RECEIPT DATE: 7/14/2014 **ONSITE SEWAGE DISPOSAL SYSTEM**

PROPERTY ADDRESS: 6227 HEATHER GLEN WAY, CLARKSVILLE, MD 21029

RE: BAT Site Plan comments, 6227 Heather Glen Way (Lot 28) JB

RE: Best Available Technology (BAT) denitrification unit and low-pressure distribution (LPD) system required at 6227 Heather Glen Way, (The Preserve at Clarksville, Lot 28)

**2** **BAT COMPONENT CROSS SECTION**  
 SCALE: N.T.S.

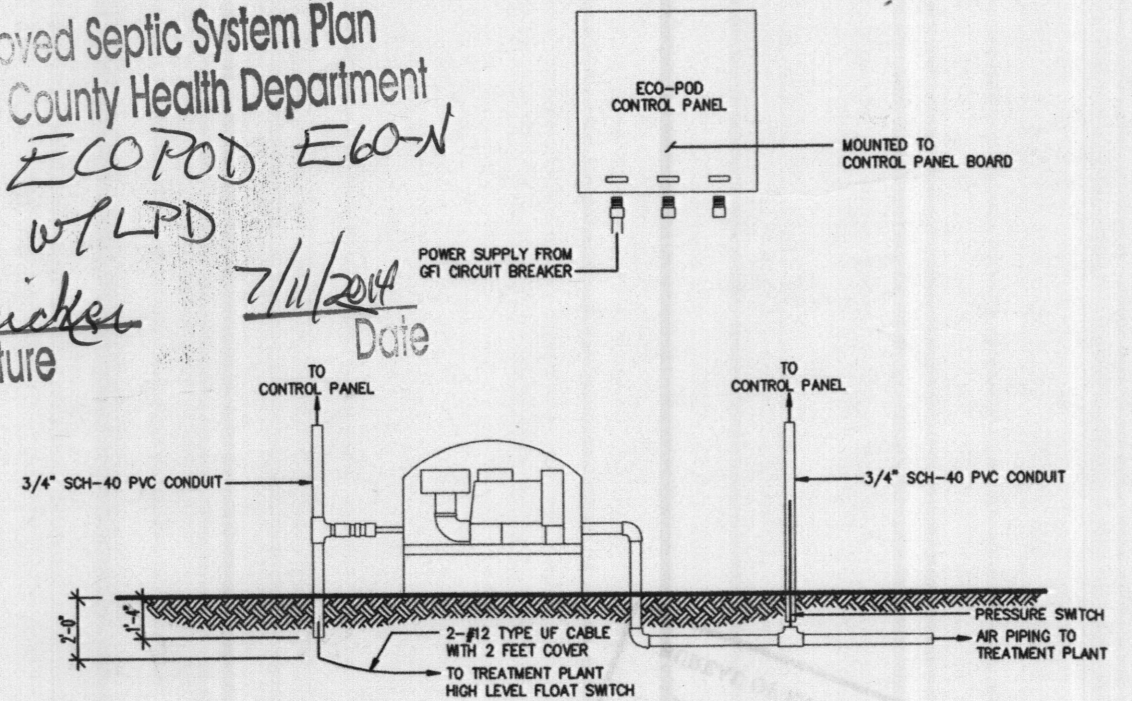
1. The graphic titled "BAT COMPONENT CROSS SECTION" is sufficient as a profile drawing, however pertinent invert elevations and ground elevations must be included.

**1 1500 GAL. PUMP CHAMBER L.P.D.**  
SCALE: N.T.S.

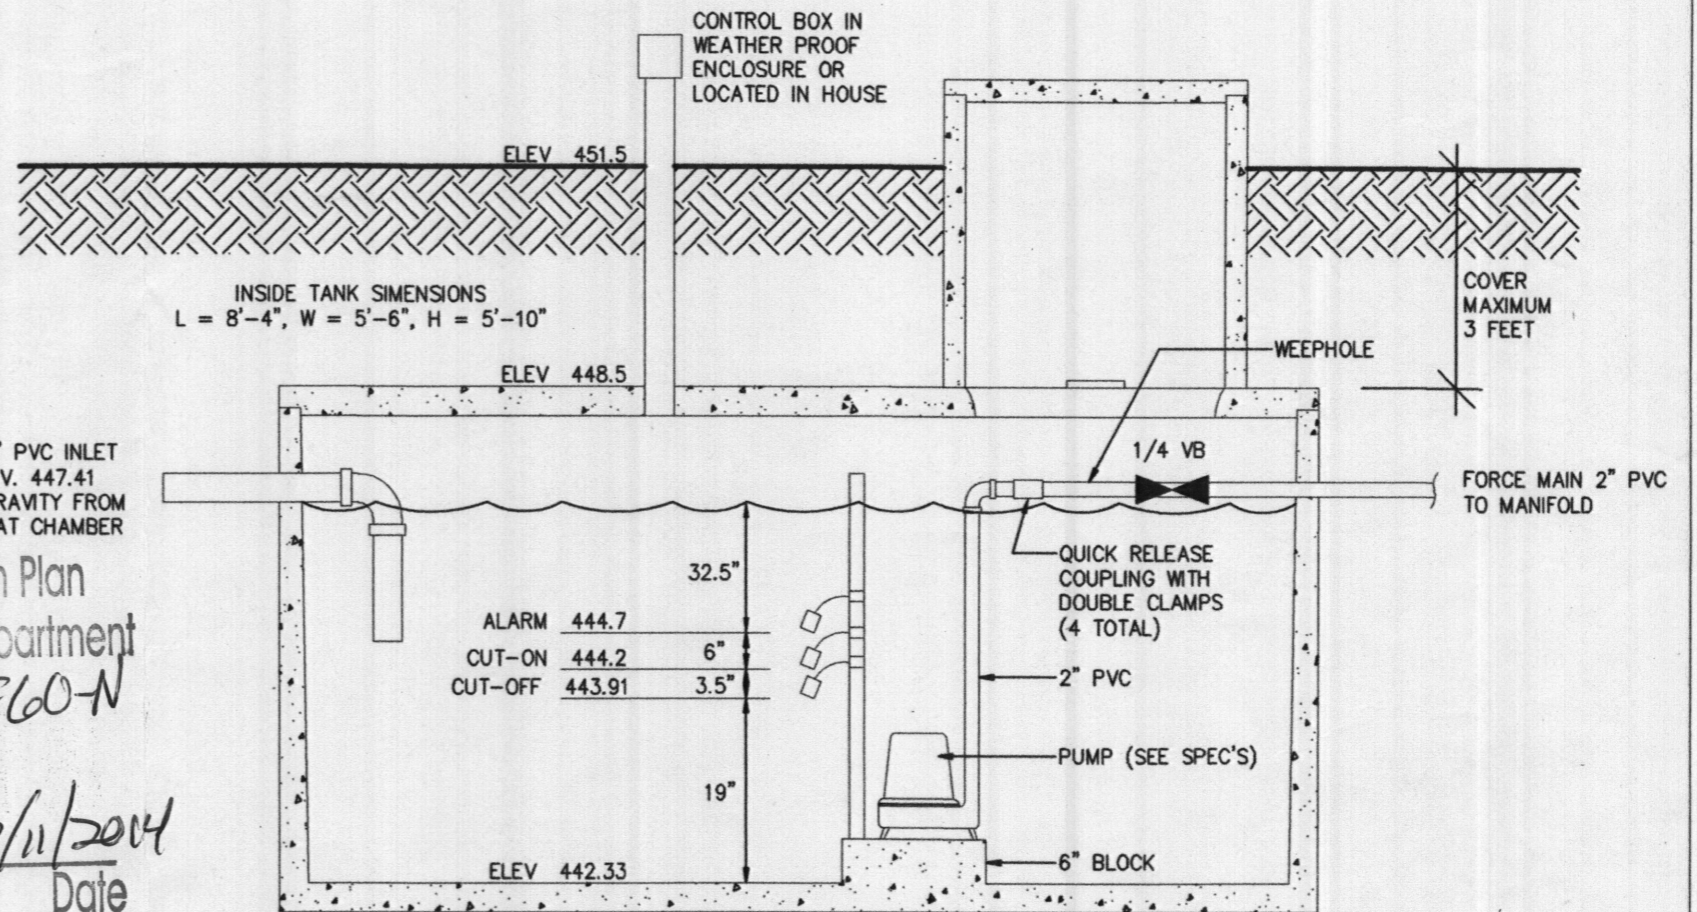
- a. A 1500-gallon pump tank with pump sized appropriately for the distribution network
- b. Details of the pump tank must be shown, Top View and Side View, including

- i. Elevations for Invert In, Tank Invert (bottom of tank chamber), Pump Invert, Pump OFF elevation, Pump ON elevation, ALARM elevation (0.5 ft above Pump ON)

- ii. Illustrate path of force main from pump and exiting tank/manhole
  - iii. Illustrate a 'weep hole' in the force main inside the tank chamber but above the ALARM elevation
